Groundwater Application Review Summary Form

Application # G- 18868

To: Kristopher Byrd, Well Construction and Compliance Section Manager
From: Joel Jeffery, Well Construction Program Coordinator
Subject: Review of Water Right Application G-18868
Date: November 27, 2019

TO: Water Rights Section Date 11/26/2019
 FROM: Groundwater Section Travis Brown
 SUBJECT: Application G- 18868 Reviewer's Name Travis Brown
 Supersedes review of _____ Date of Review(s) _____

Well Statistics – T5S/R2W Sections 13, 24, and 25

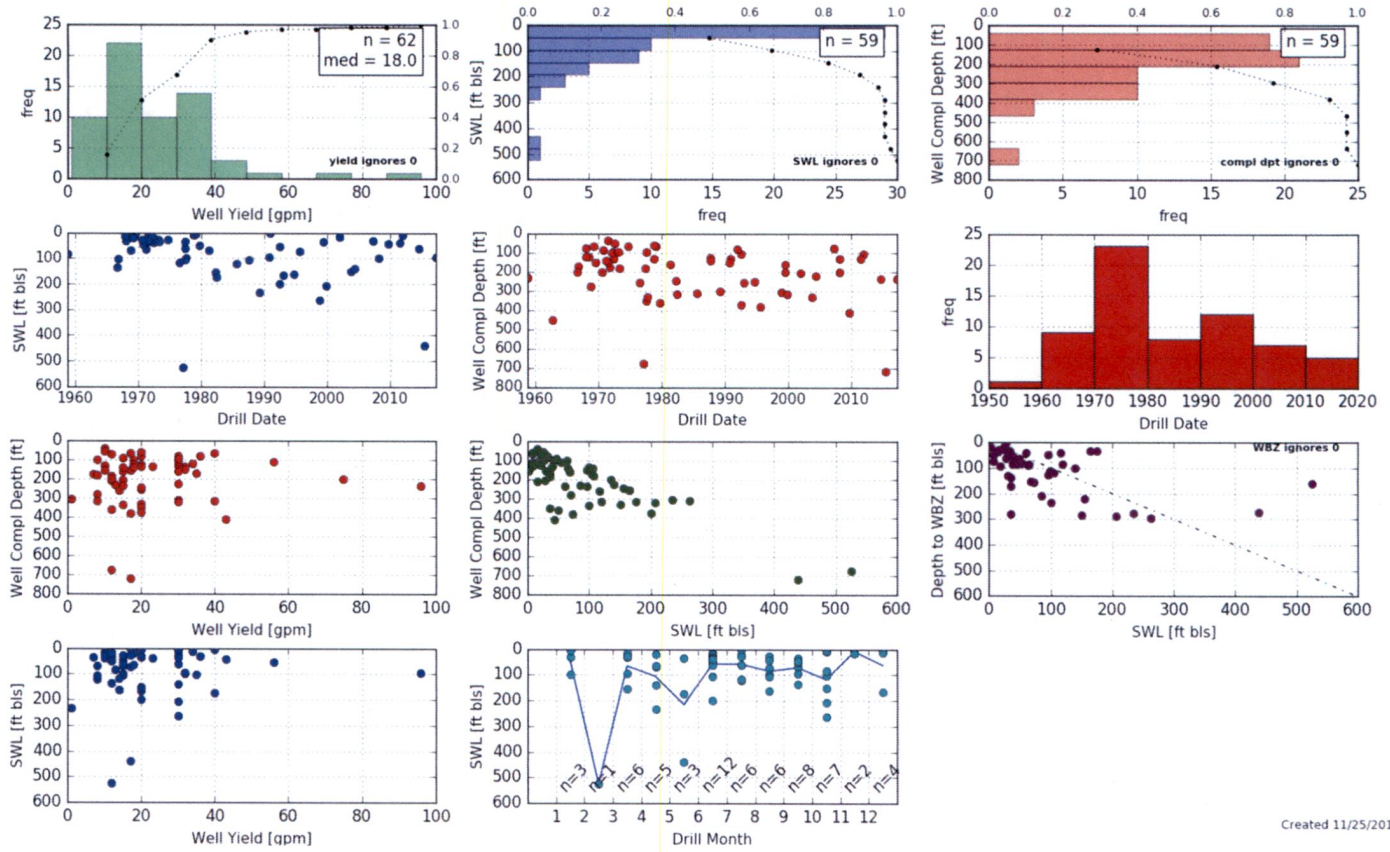
The proposed POA has a reported yield of 96 gpm (~0.214 cfs), based on only a 1-hour air test during completion of the well. This yield is anomalously high compared to reported yields for other wells in the same and adjacent sections (see attached Well Statistics). The reported yield for the proposed POA is more than 530 percent of the median reported yield in this area (~18 gpm) and nearly 130 percent of the next highest reported yield of 75 gpm (CLAC 54633). Based on the nearby well statistics, it would appear highly possible that the reported yield of 96 gpm for the proposed POA is an overestimate of the well's sustainable yield. Furthermore, even at the reported yield of 96 gpm, the proposed POA would only be capable of supplying ~48 percent of the total maximum rate requested of 0.45 cfs. **Therefore, the proposed POA would appear unable to provide the requested allocation within the capacity of the groundwater resource.**

Hydrograph

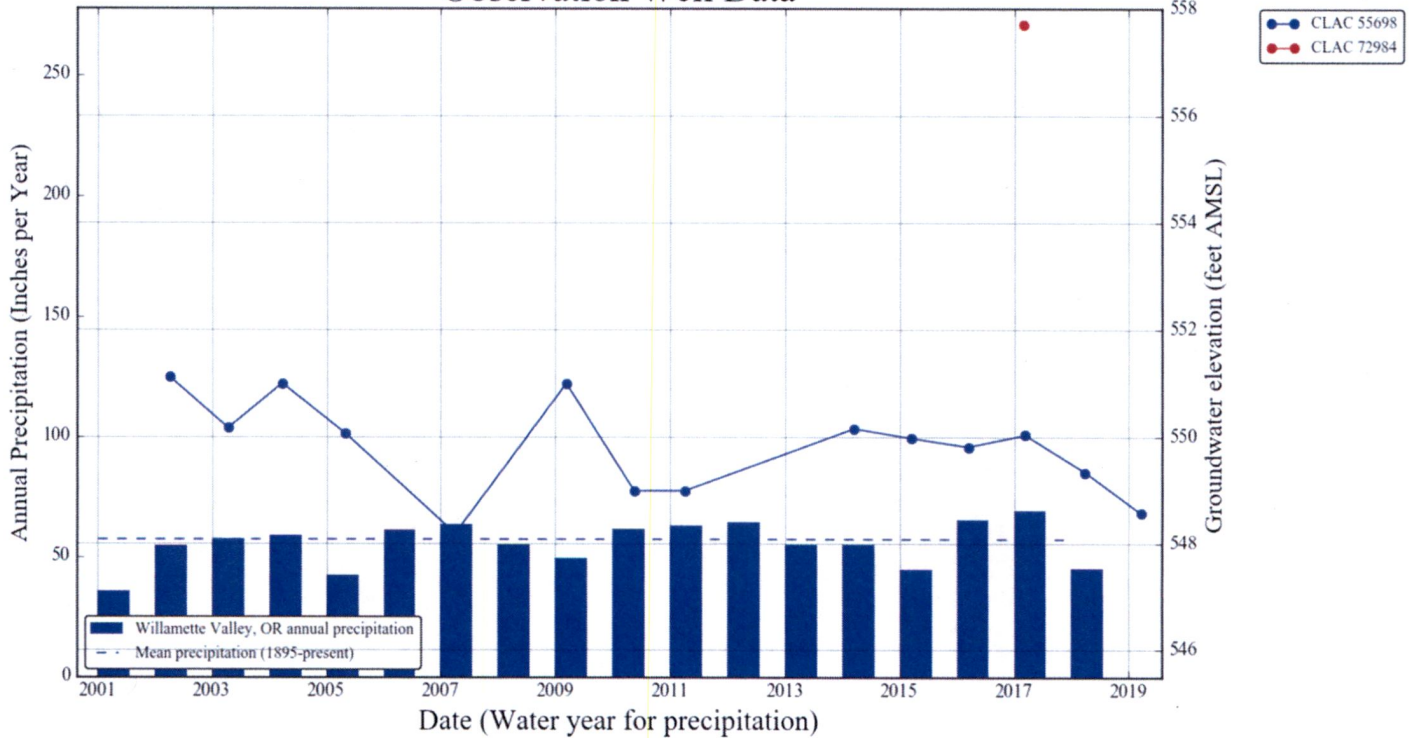
The nearest relevant observation well (CLAC 55698) to the proposed POA shows a very modest decline over the past decade, with considerable year-to-year variability (see attached Hydrograph). The conditions detailed in Item B1(d)(i) and B2(c), above, are recommended for any permit issued pursuant to this application in order to protect senior users and the groundwater resource.
